SERVICE **TEK** NOTES

**ECO170A/SPG170A/TSG170A/TSG271/TS
G300/SPG271: Power Supply Redesigned**

MANUAL CHANGE INFORMATION

Change Reference: C6-1088Product: 1730/1731 OPT 16Manual Part No: 070-4474-02**ELECTRICAL PARTS LIST AND SCHEMATICS CHANGES****CHANGE TO READ:**

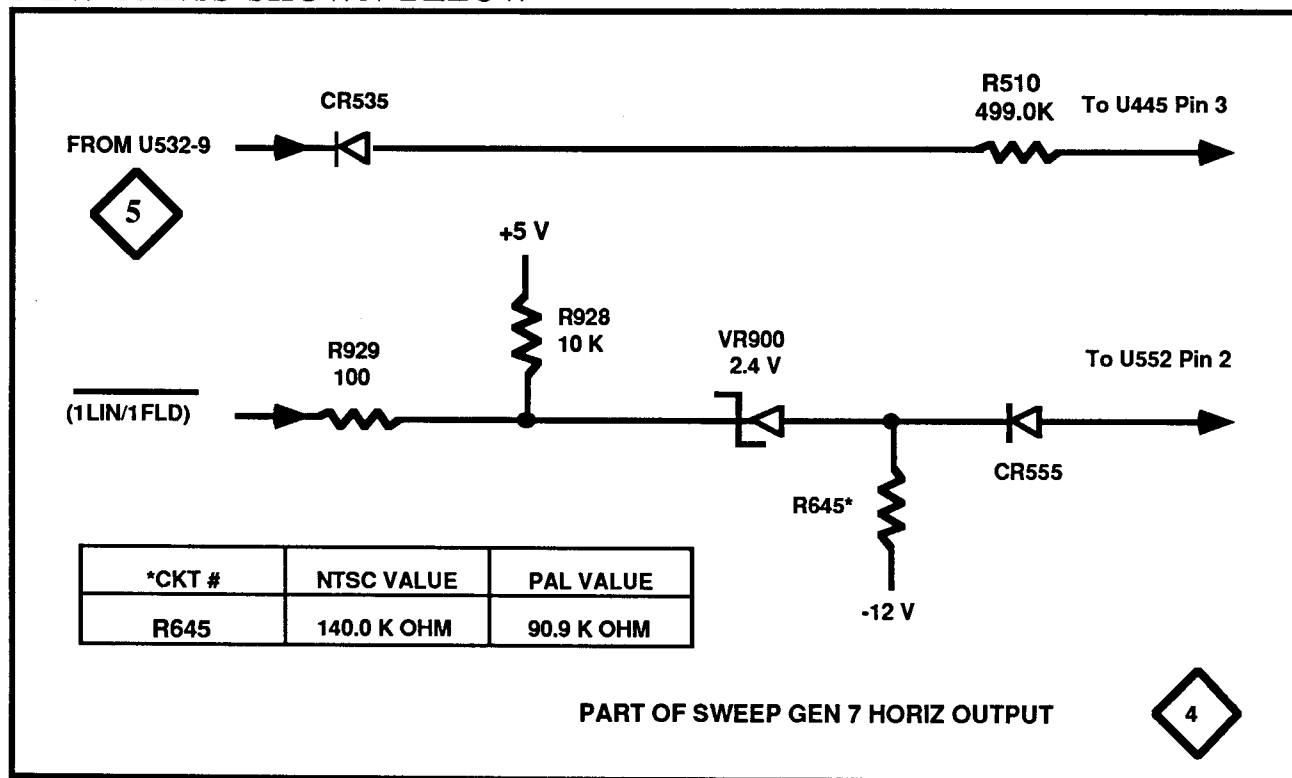
ADD:

Add Step 7a Short Form Check Procedure, Page 5-4 with:

Add Step 7a Check Procedure, Page 5-7, with:

ADD:
